**STAFF SUMMARY REPORT**

LARGE-SCALE DEVELOPMENT - FIRST STREET STORAGE

PROJECT NAME:	First Street Storage
PROJECT DESCRIPTION:	Self-storage facility with office and commercial buildings totaling 63,846-sf
ADDRESS/LOCATION:	1911 S. 1st Street
GROSS SITE AREA:	4.27 ± acres
RESIDENTIAL UNITS:	N/A
REQUESTED WAIVERS:	Street Improvements
REQUESTED VARIANCES:	N/A
FEES-IN-LIEU:	Street Improvements (amount TBD)

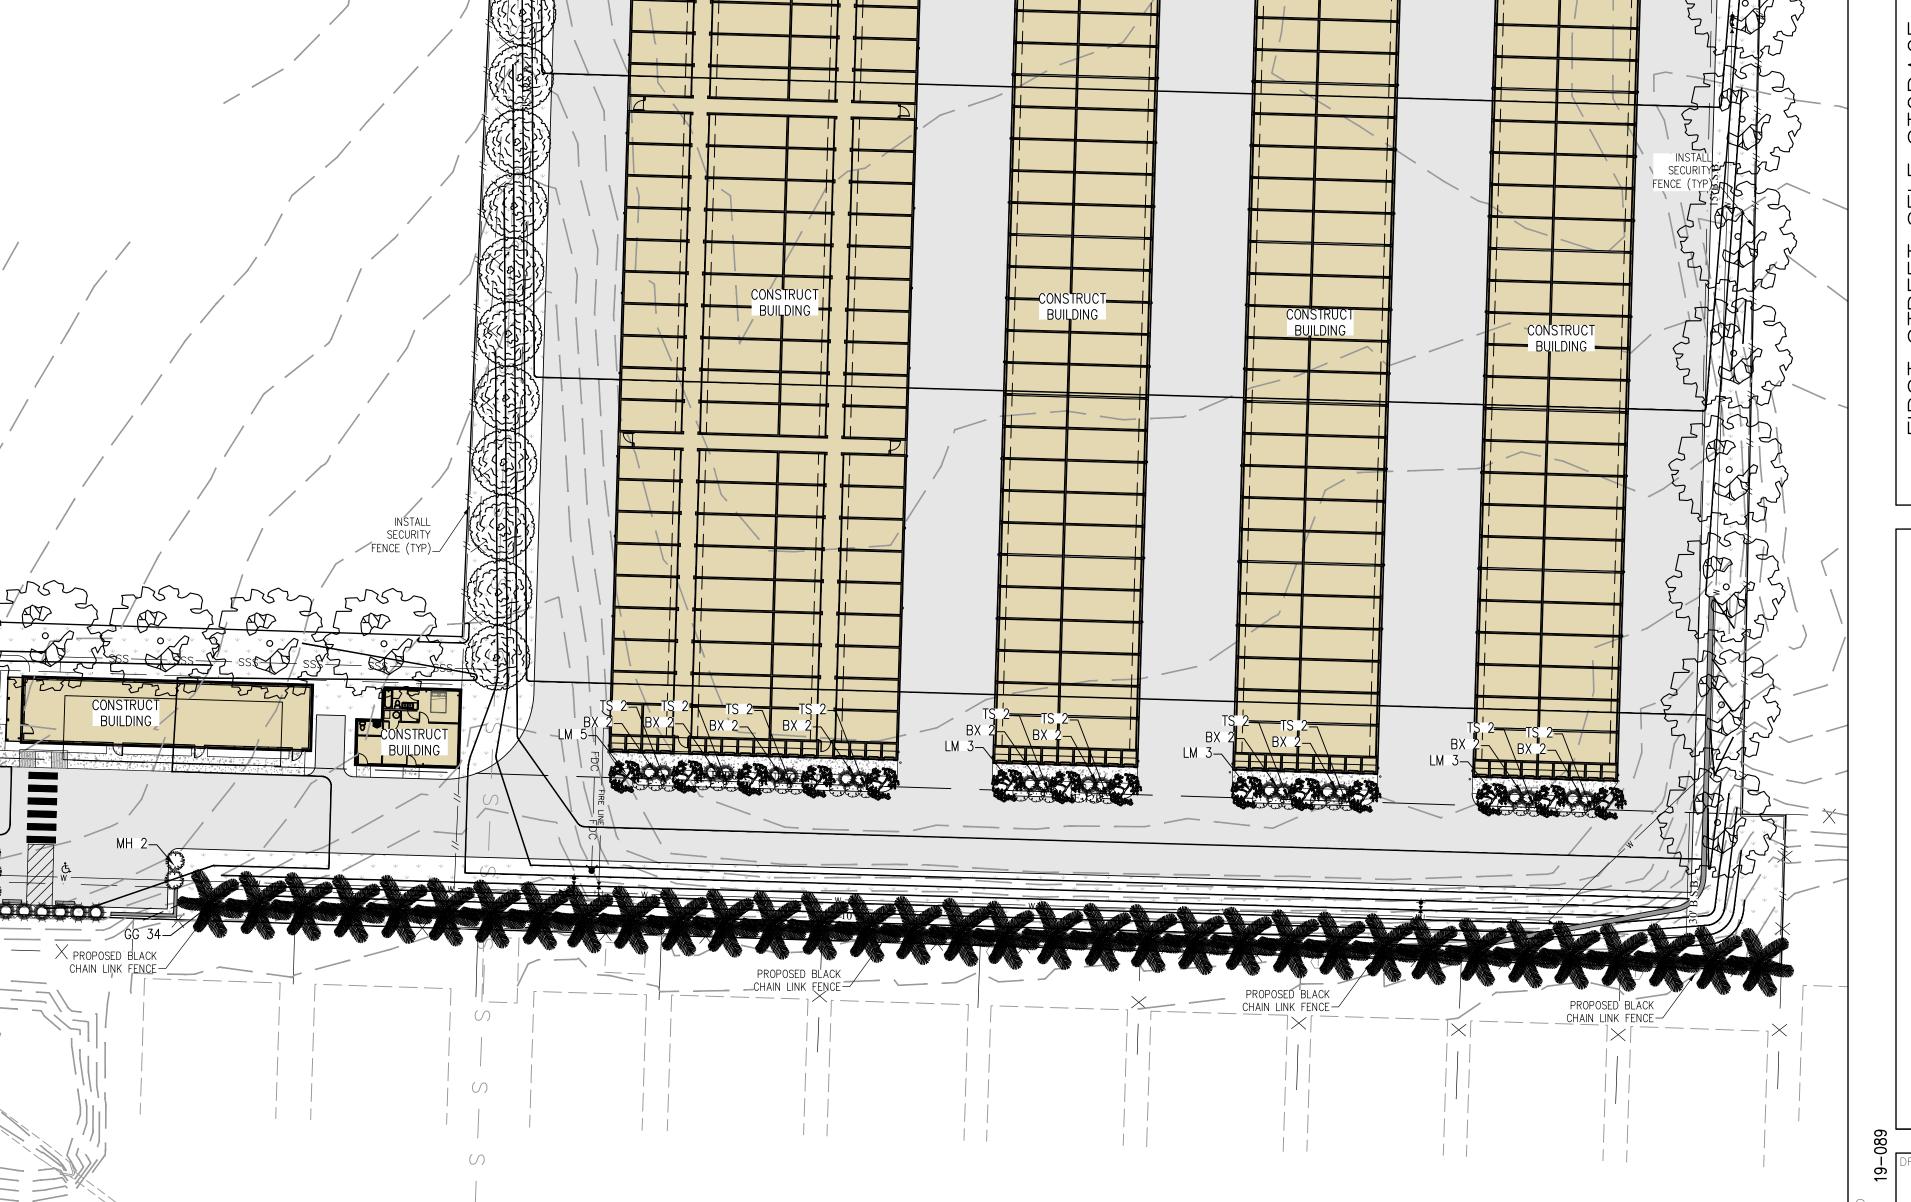
- 1. ACCESS MANAGEMENT: The applicant's request meets the City of Rogers access management standards.
- 2. STORMWATER MANAGEMENT: The applicant proposes a retention along the north end of the project. The applicant is required to show a Drainage Easement connecting from the retention to the property line at the spillway, and replace the proposed rip-rap with an appropriate material to be consistently shown across the plan. Engineered plans are required for the wall over 4' tall to carry a swale from the southeast of the property to the detention pond. The slopes along the detention pond are 2:1 and are required to be changed to a 3:1 or less slope.

PE PLAN 2019000321 RKANSAS SELF CAP #PL2 STREET CALE D ROGER LANDS  $\overline{\Box}$ FIR

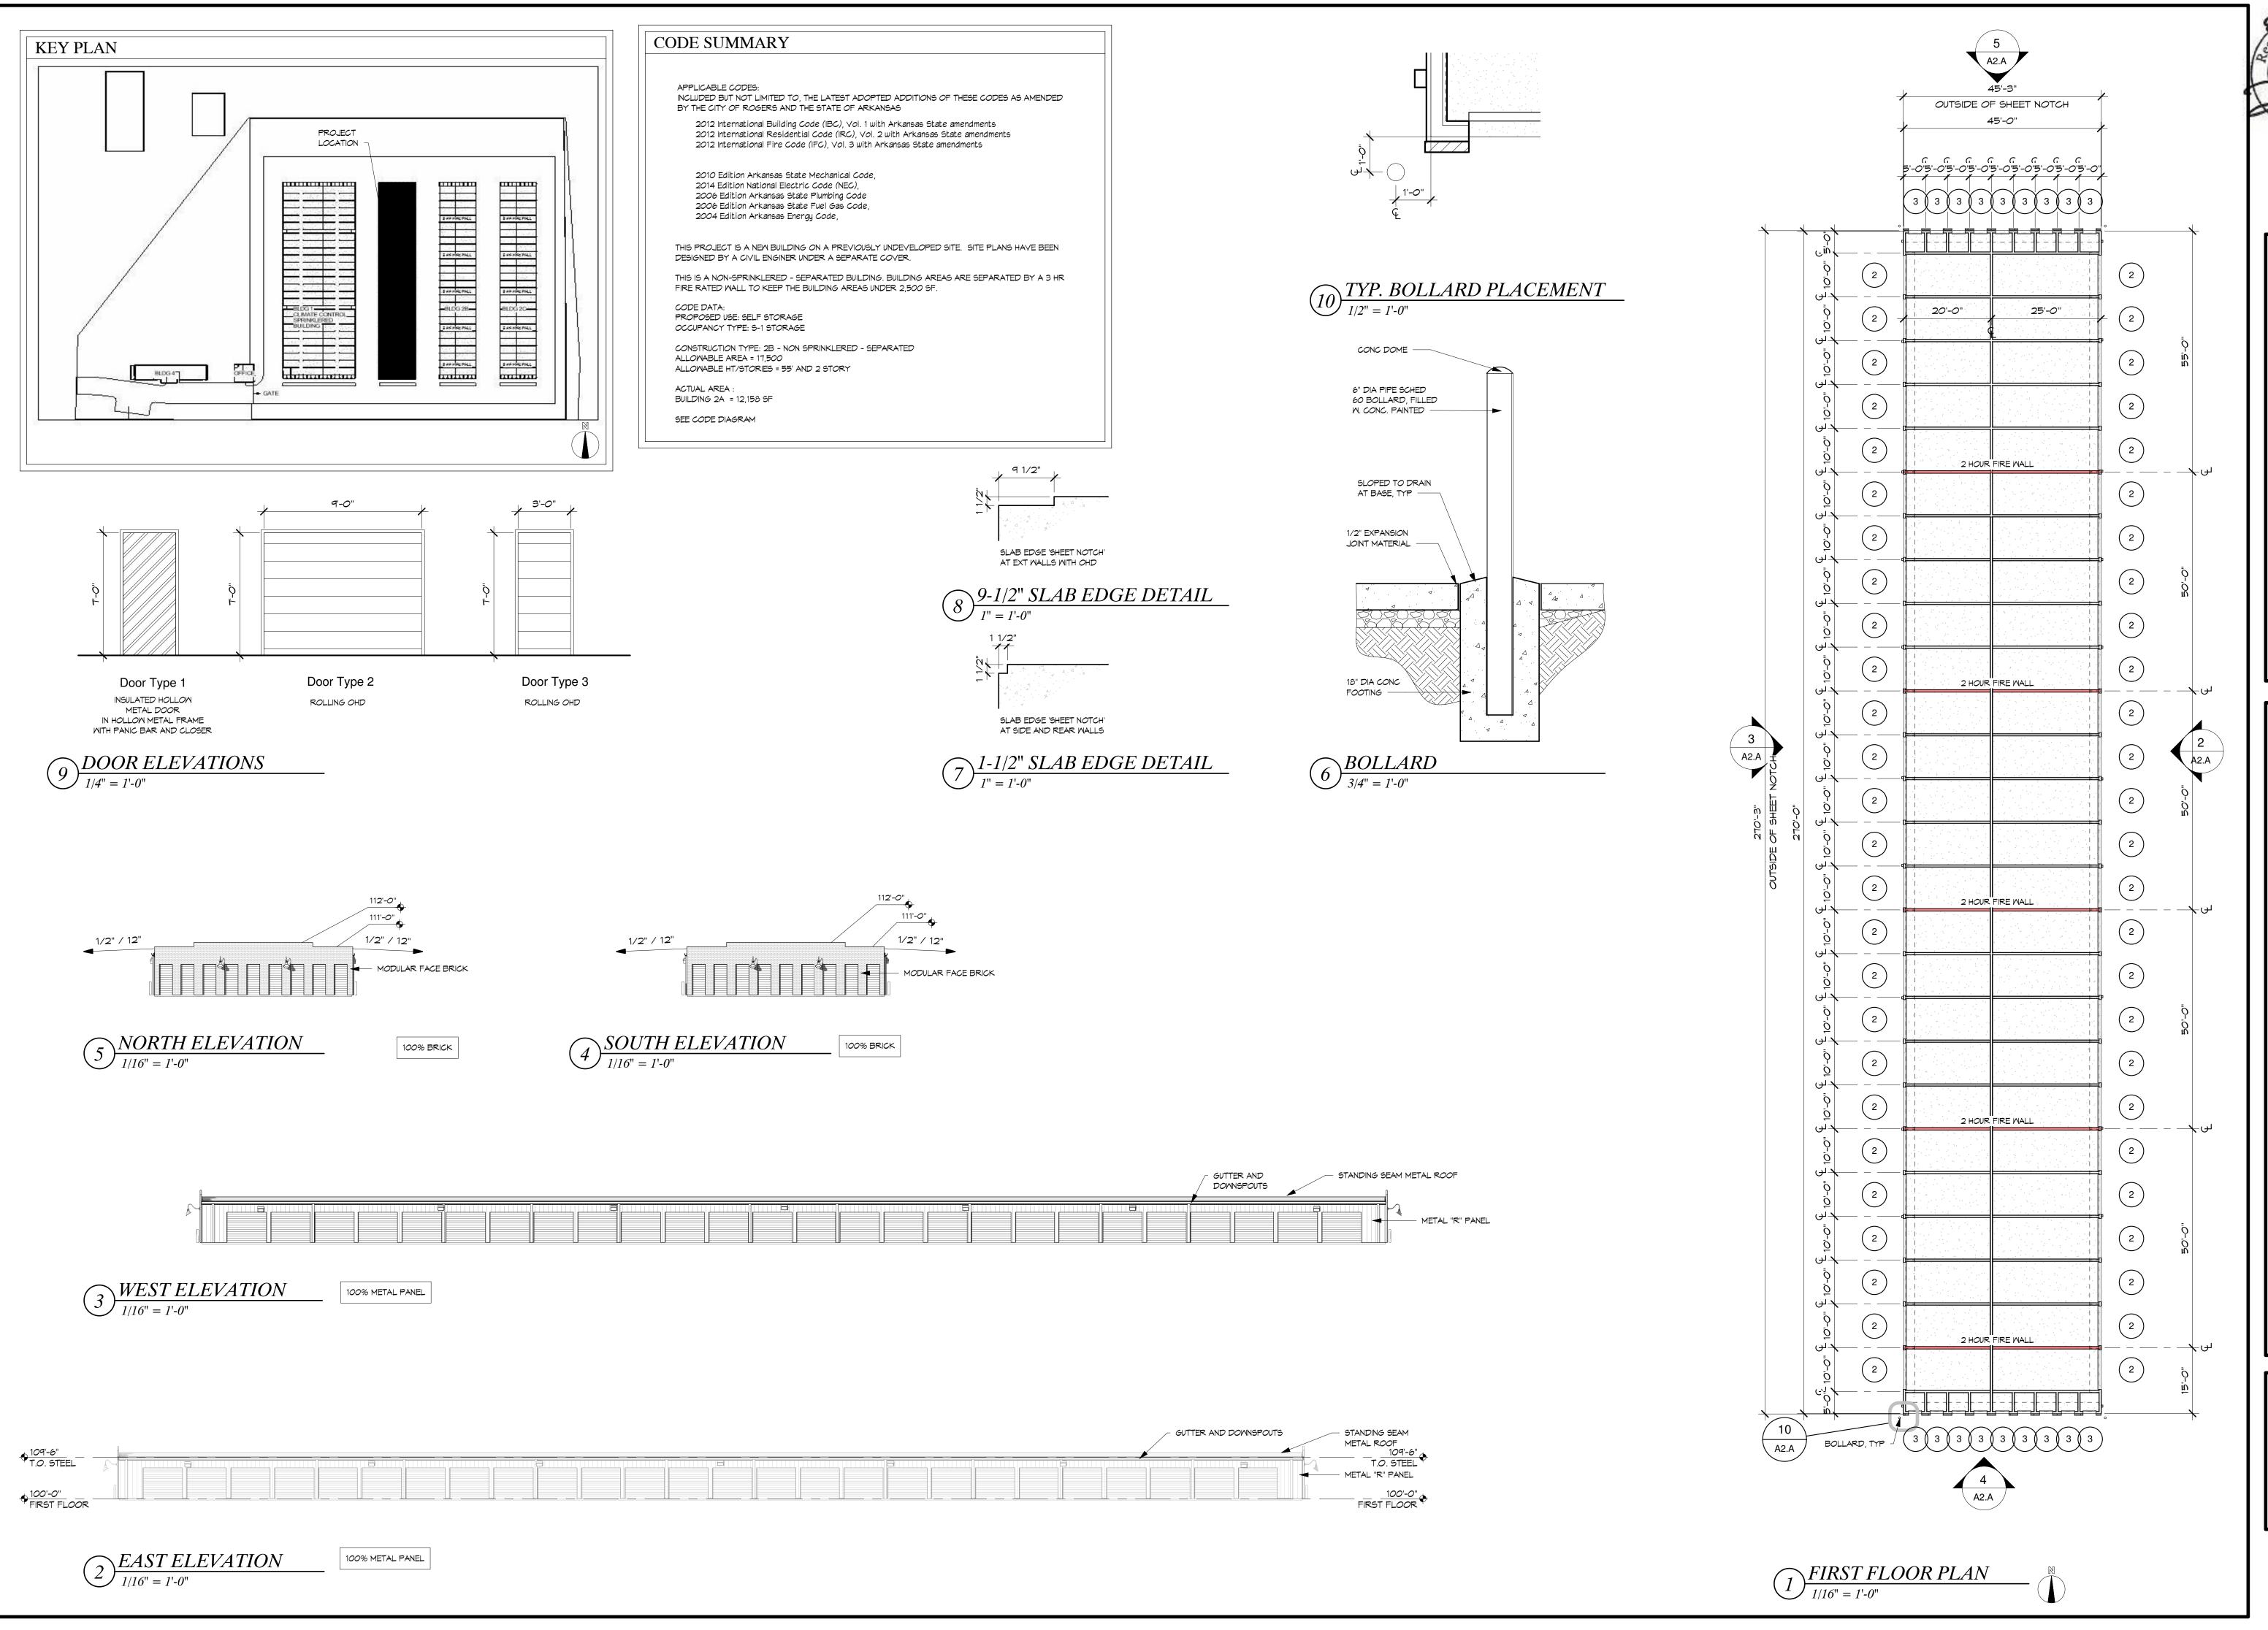
8. Large trees (over 20' tall at maturity in City Code 14-46-paragraph G) must be located at least 10 feet from any water or sanitary sewer main. (There appears to be a cypress tree that will be too close to the existing sewer main.)
